Project
WATERLOO METRO QUARTER DEVELOPMENT

Sheet title
General Arrangement Plan
Level 01

Status	Revision
AFT D&C Builder	0
Sheet number	Revision
WMQ-BLD4-BSA-AR-DRG-DA101	0

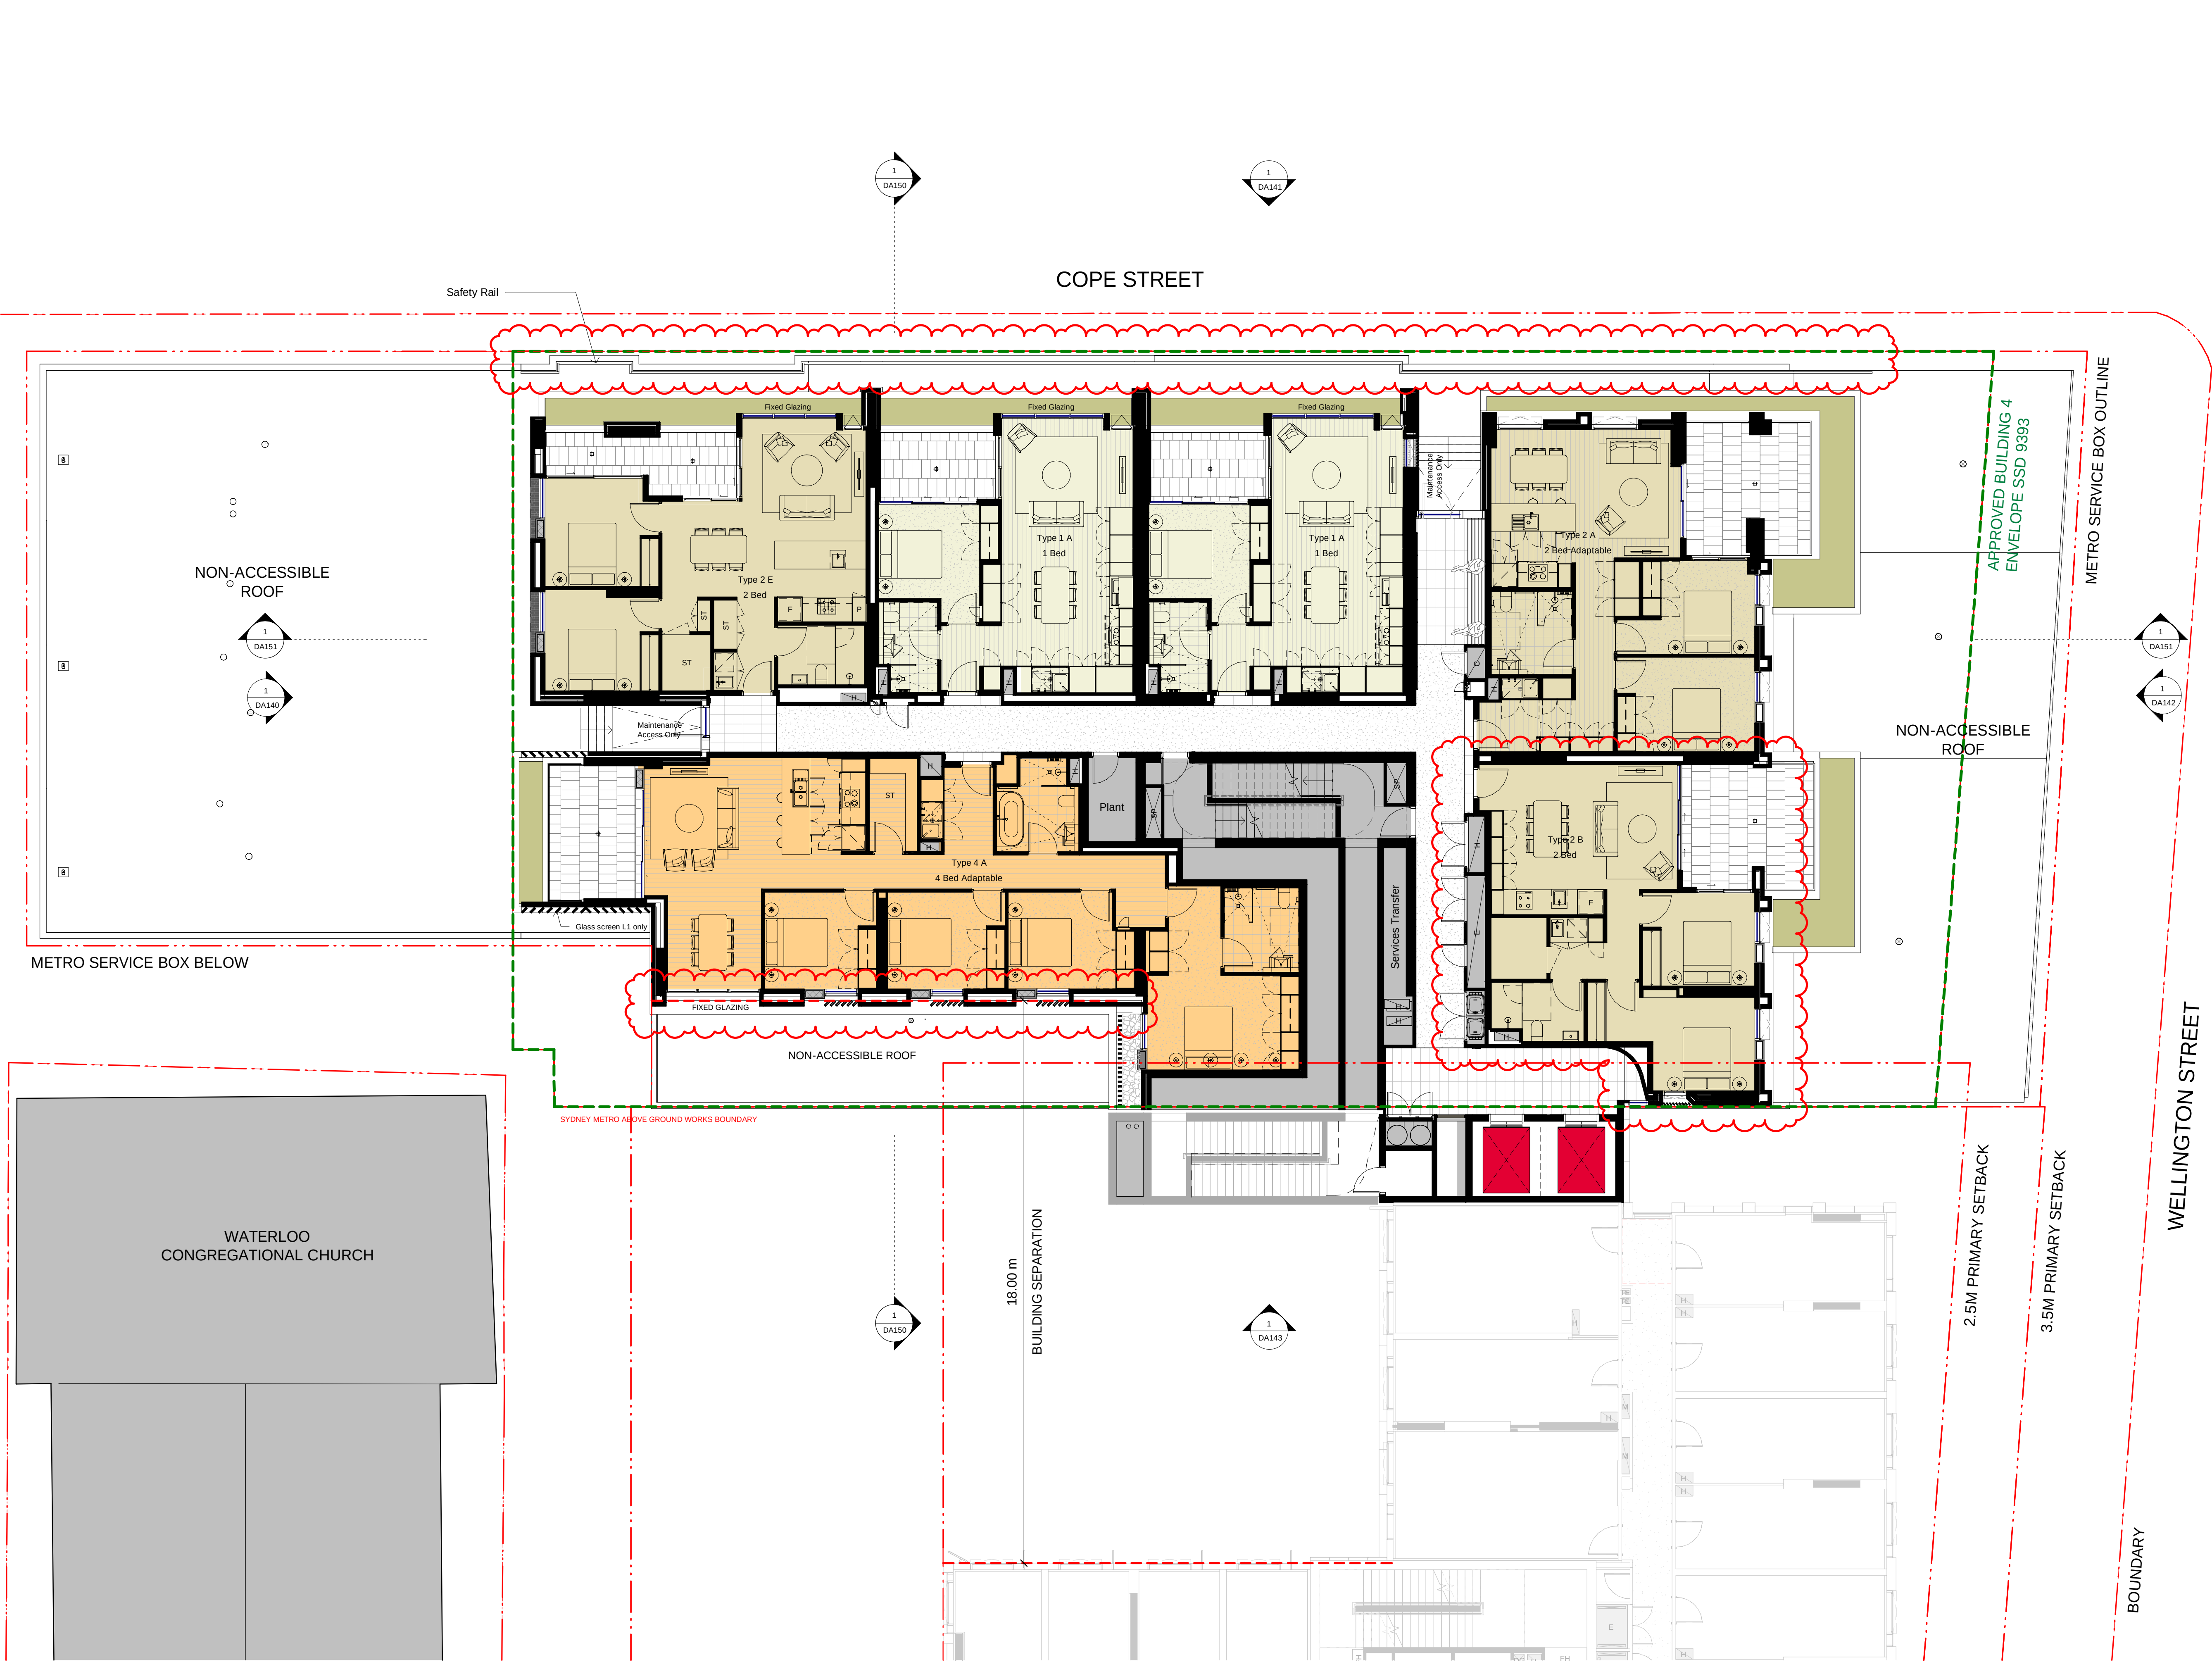
- Changes for Return to submission
- Services reconfiguration
 - Western Facade
 - Type 2B Apartment reconfiguration
 - Addition of safety rail on station roof

Level 08

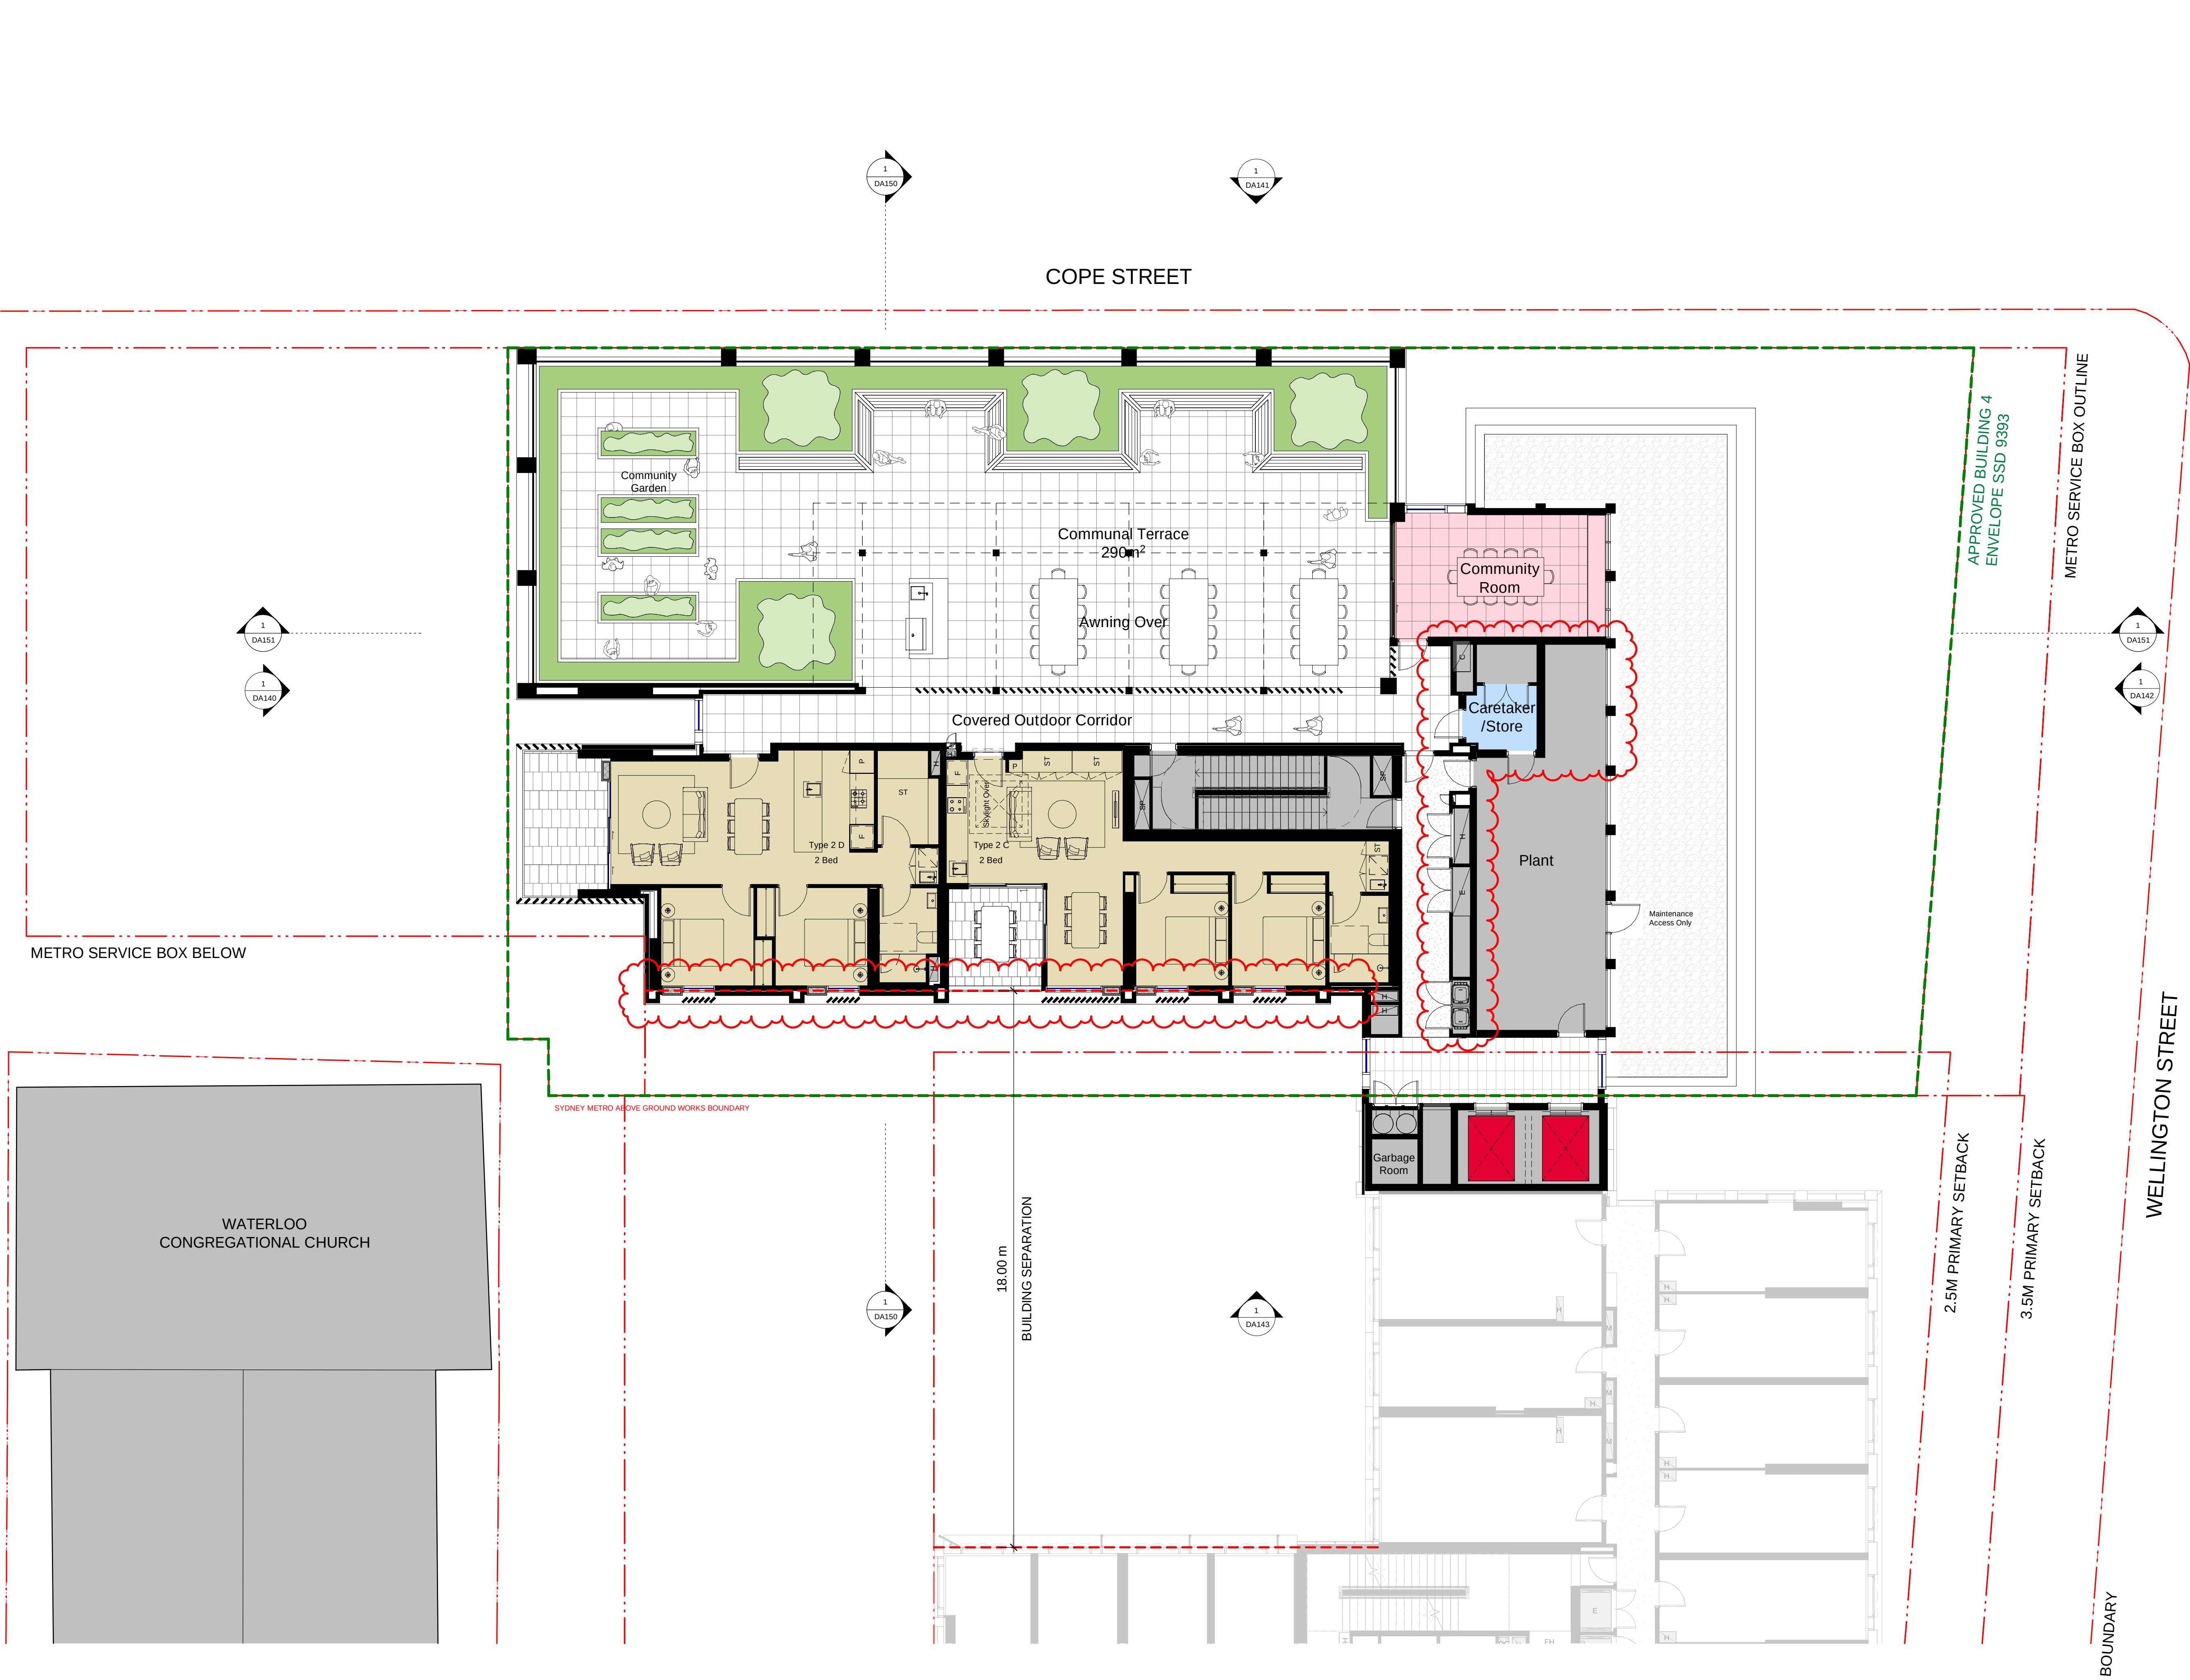
Changes for Return to submission

- Services reconfiguration
Western Facade
Type 2B Apartment reconfiguration

Level 09

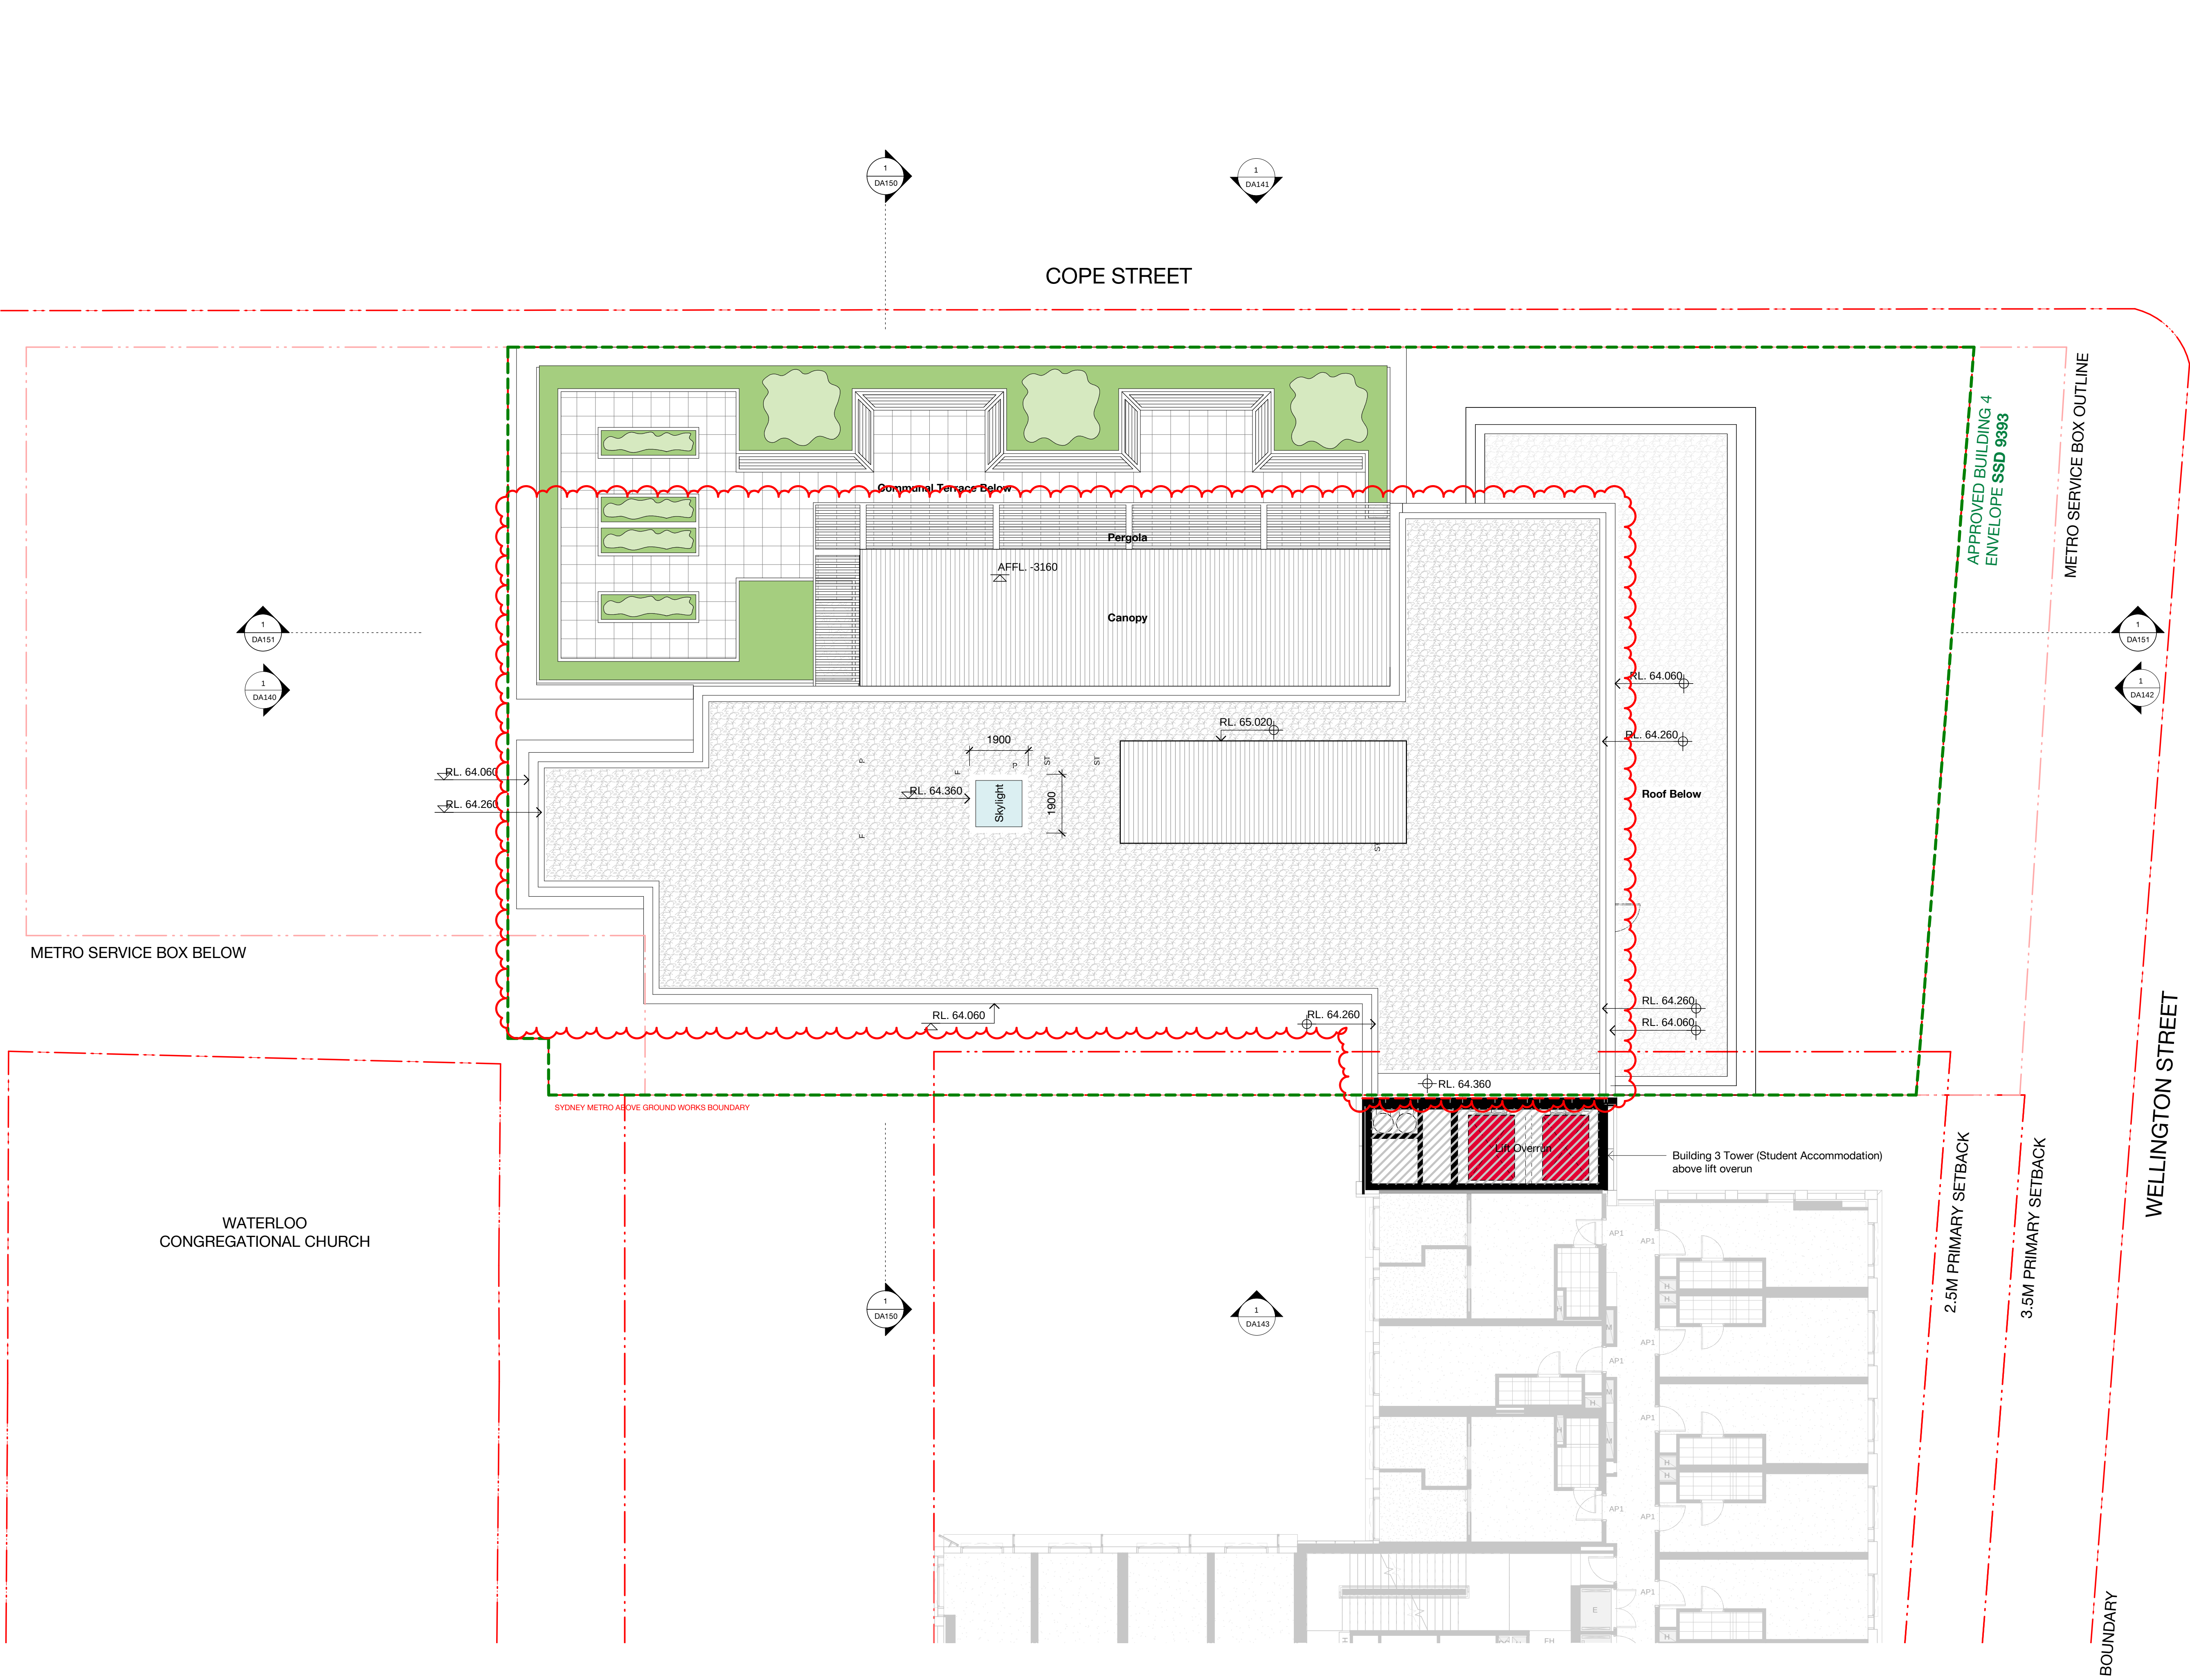
- Changes for Return to submission
- Services reconfiguration
 - Western Facade
 - Caretaker / Store reconfiguration
